Access Compliance Report

Public Rights-of-Way

(Curb Ramps)

Intersection ID: 52135	Main Street: ARDREY_KELL_RD	Cross Street: JUNIPER_TRACE_DR	Location: SW
ADA ID: 2126C28F6E34	Ramp Type: BlendTrans1	Initial Pass/Fail: Pass	Overall Compliance: No
Severity Score: 0			
Codes/Mitigation Info/Possible Solution		Field Measurements/Component Compliance

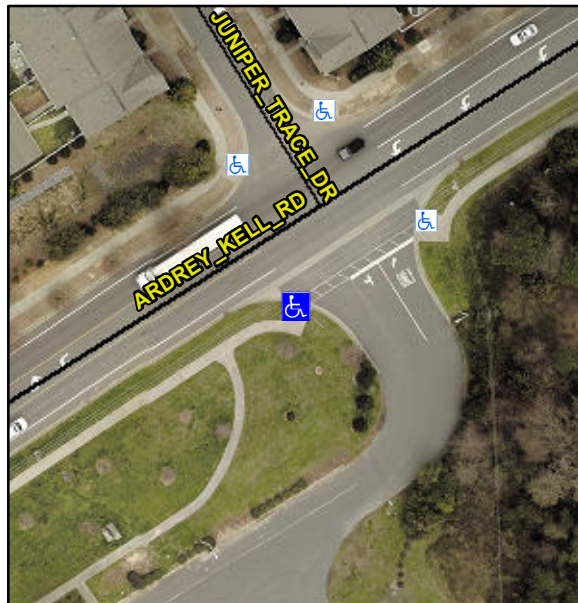
Not Found, R304.2.2-Perp, R304.3.2-Para, R305.2

Yes	Ramp inside XWalk1?	Yes	N/A	Ramp inside XWalk2?	N/A
	Road Slope (%)	1.3		Clear Space?	Yes
	Road X Slope (%)	1.1	N/A	Clear Space to XWalk (in)	N/A
Yes	Any Obstructions?	No	Yes	Storm Grate/Utility Hazard?	No
	Obstruction Type			Storm Grate/Utility Type	
		N/A			N/A
			Yes	Surface Condition? (G/P)	Good
			No	Curb Slope (%)	15.9

Remove & Replace Curb Ramp With Two New Directional Ramps or Equivalent.
